Check brake pads and the caliper from tilt system

Model: Rapid 3 XL (RP3)

1. Check the caliper from rear-right perspective of the seat apron.

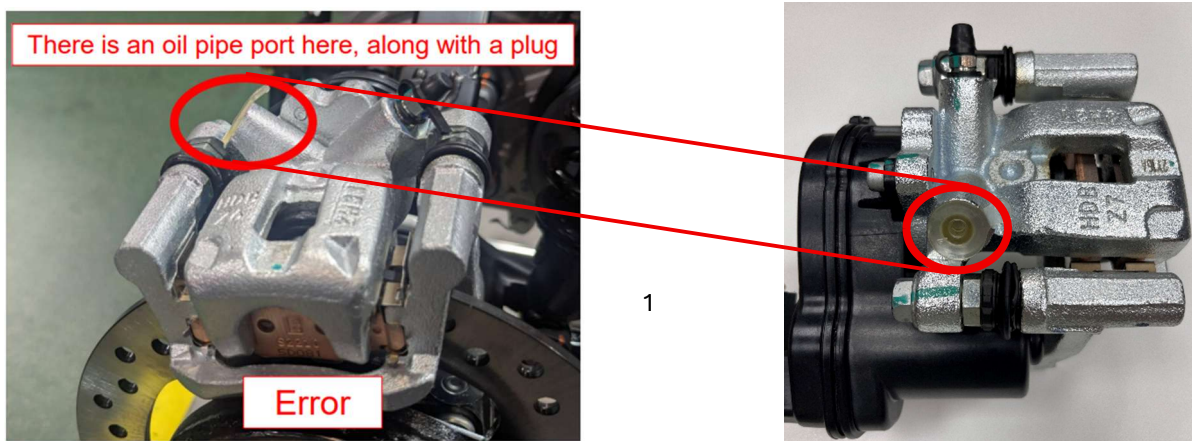
Correct caliper: The blue part should be flat without any pipe hole. Then, jump to Step.2

Incorrect caliper: If the vehicle is incorrectly equipped with the wrong caliper, please replace the caliper. (Refer to service manual **15001 Replace the Tilt Brake Caliper**)

2. Check the production number on brake pads.

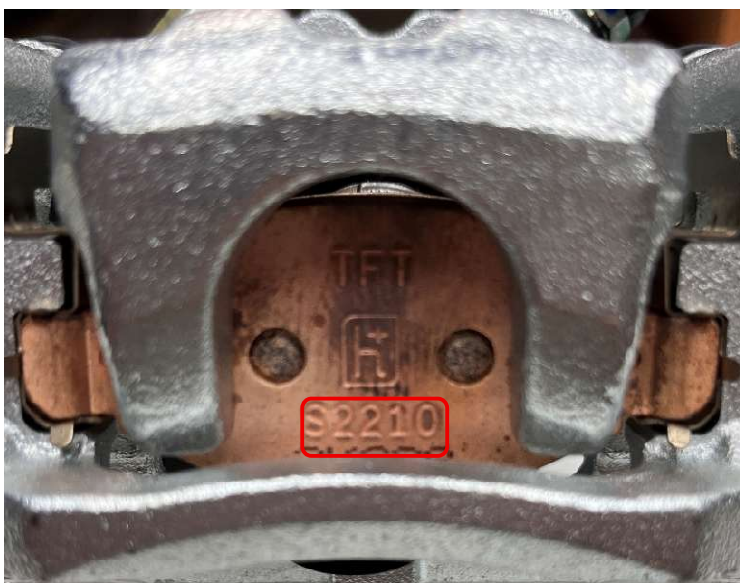
Correct production number: S6601

Incorrect production number: S2210 or other production number.

Please replace a pair of brake pads.(Refer to service manual
15002 Tilt Brake Pads)
